**Attachment 1 Responses-to-Comments Table**

Application for Amendment of Plan Under Section 12A of the Town Planning Ordinance (Cap.131), to Rezone the Application Site from “Open Storage”, “Agriculture” Zones and an area shown as ‘Road’ to “Other Specified Uses” annotated “Mixed Use” Zone, for Proposed Mixed Use Development at Lots 796 and 1008 RP in D.D. 77 and Adjoining Government Land in Ping Che, Ta Kwu Ling, New Territories  
 Response to Departmental Comment

(Last Updated: 26 February 2024)

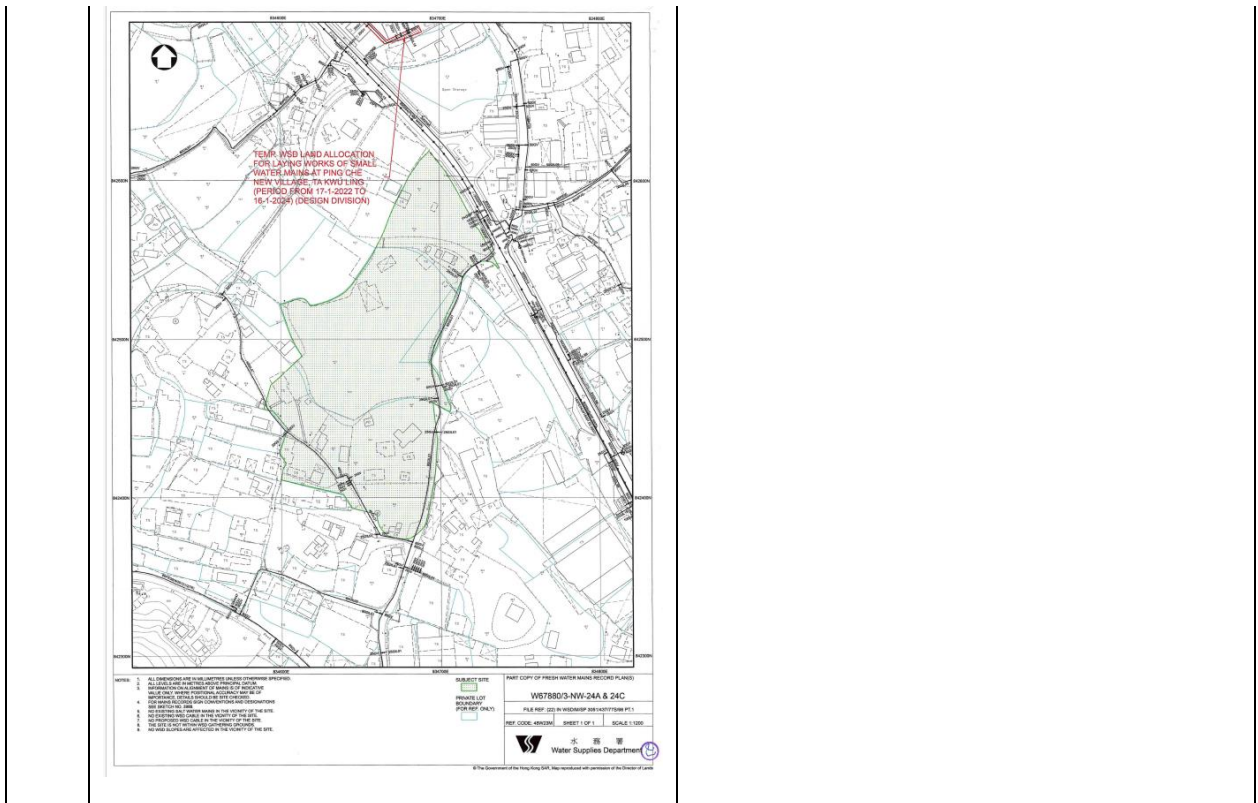
59 .Section 3.1.4  (a) 3rd bullet point: Please amend “WPCO-TM” to “TM-DSS”. [ <i>not yet addressed in previous round of comment</i> ]  (b) Please delete second last bullet point.	Noted. Information has been supplemented in Section 3.1.4 of <b>Annex C</b> .  Noted. Please refer to the updated Section 3.1.4 of <b>Annex C</b> .
60 .Please confirm if there is nearby public sewer, if yes please connect to public sewer for disposal of sewage generated from the proposed development instead of adopting sewage treatment plant (STP).	Noted. There is a series of rising main public sewers found along Ping Che Road. There is no other public sewer and manhole nearby the proposed development. Hence, STP is adopted.
61 .If STP is to be adopted, please explain the treatment level of the proposed STP and provide design and relevant details of the STP with figure illustration. [ <i>not yet addressed in previous round of comment</i> ]	The proposed development falls within the Deep Bay Water Control Zone (WCZ). The proposed STP will be designed to meet the acceptable treatment level of the Deep Bay WCZ. Please refer to information supplemented in Sections 4.4.3, 4.4.4, 4.4.5, Table 4-3 and Appendix C of <b>Annex C</b> .
